Re: **Notice of Site Assessment Review**
Ash Grove Cement – Rivergate Plant
13939 N. Rivergate Blvd.
Taxlot ID 2N1W26C 0700
Portland, Oregon
Multnomah County
ECSI # 4696

DEQ SITE ASSESSMENT PROGRAM – SITE STRATEGY RECOMMENDATION

Site Name: Ash Grove Cement – Rivergate Plant

Figure 4: Aerial photograph showing river area of Ash Grove Cement site and 1995 dredge prism area. (2008 from Google Maps)

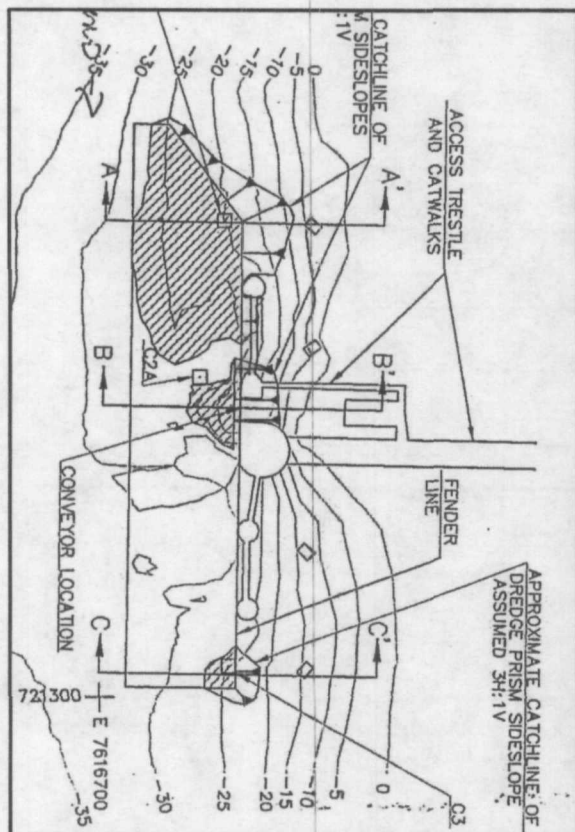
A closer inspection of more recent aerial photographs (2007) does indicate an area along the northwest edge of the property where there does appear to be some spill-over of lightly colored, grayish material that has either drained or been pushed towards the river by what appears to be a small road. This feature is noted on Figure 4.

Surface waters – Potential discharge of contaminated stormwater runoff from the site appears has occurred periodically, but rarely – there are three documented instances. DEQ does recommend that the area in the northwest corner of the site should be examined more closely based on our review of recent aerial photographs.

Since this site is adjacent to the Willamette River, DEQ recommends further investigation of the shoreline area, discharge points from AGC, such as the northwest corner, and sediments around the dredge prism area to determine: (a) the extent of dredge contaminants and possible sources; and (b) areas of suspected quicklime discharge. Since the site is within the Portland Harbor Study Area DEQ believes that further investigation in this area is warranted.

Dredge prism and sample locations – excerpt from 2005 Sediment Data Report

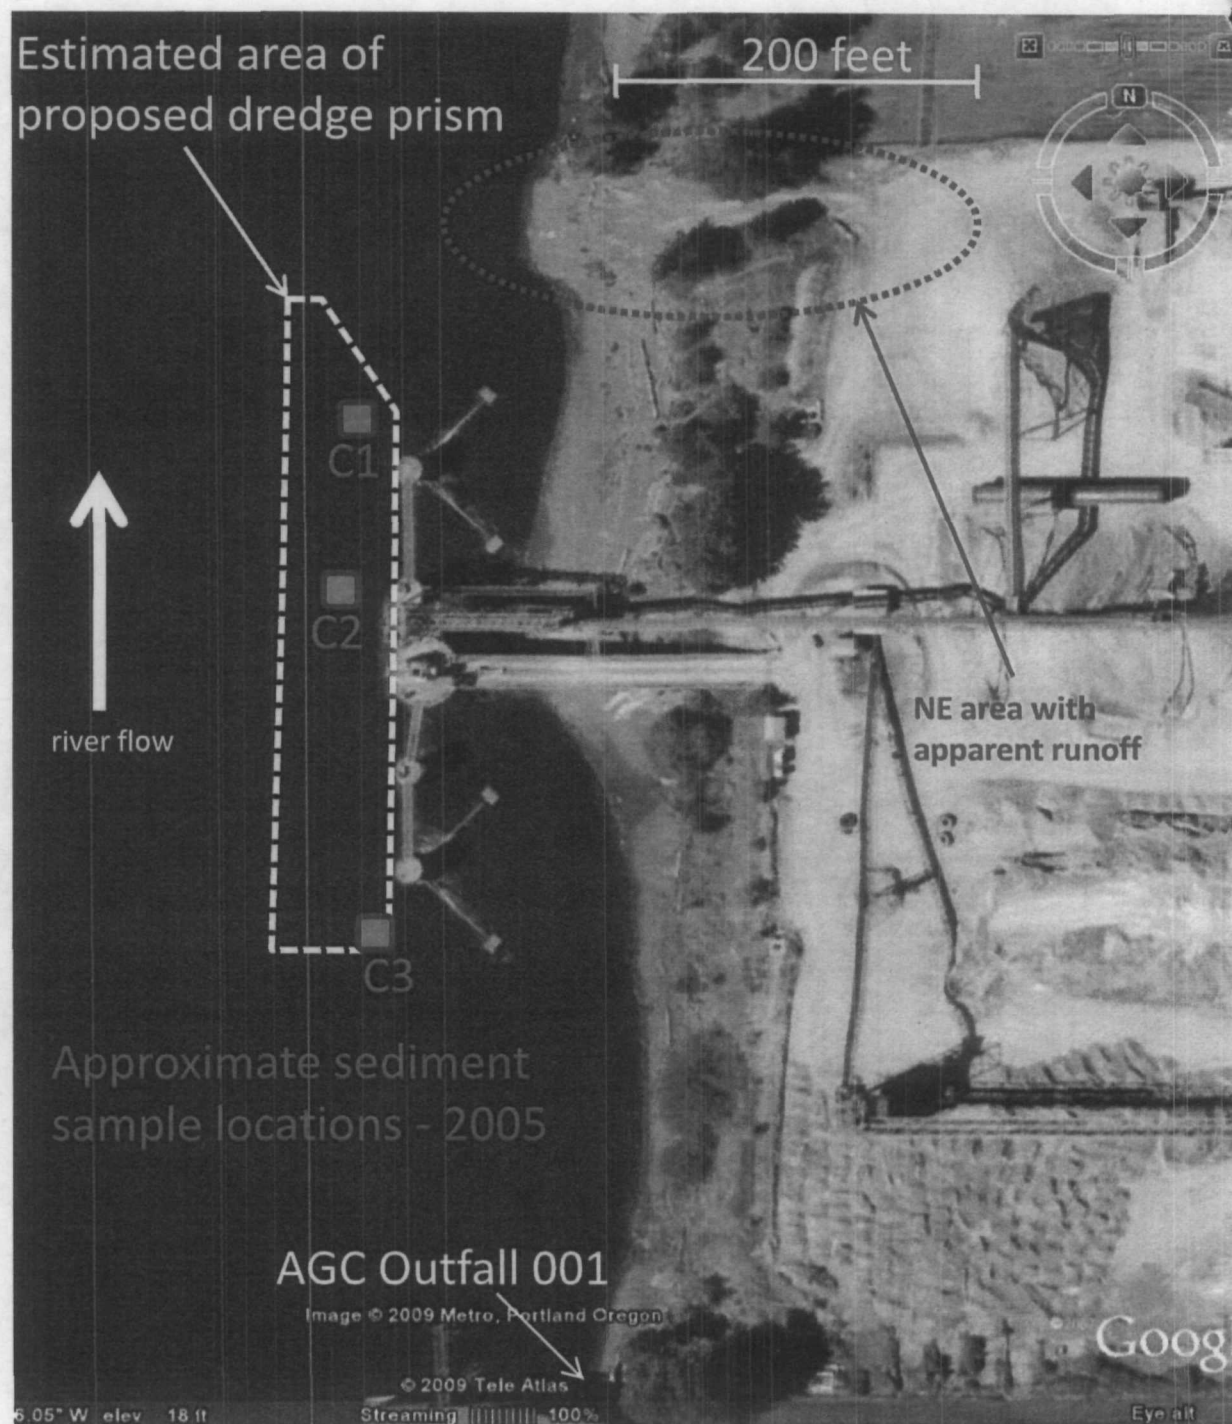
- Sources of contamination in area surrounding dredge prism – DEQ also believes it would be worthwhile to perform further investigation in the area in and around the dredge prism samples collected in August of 2006 in order to determine possible sources

The measured contaminant concentrations in the dredge prism area alongside the AGC pier are at levels that pose a threat to aquatic species, but the exact source or sources is not yet known.

DEQ's review did not find any specific source area or discharge point that directly links the site to the contaminants found in the dredge prism.
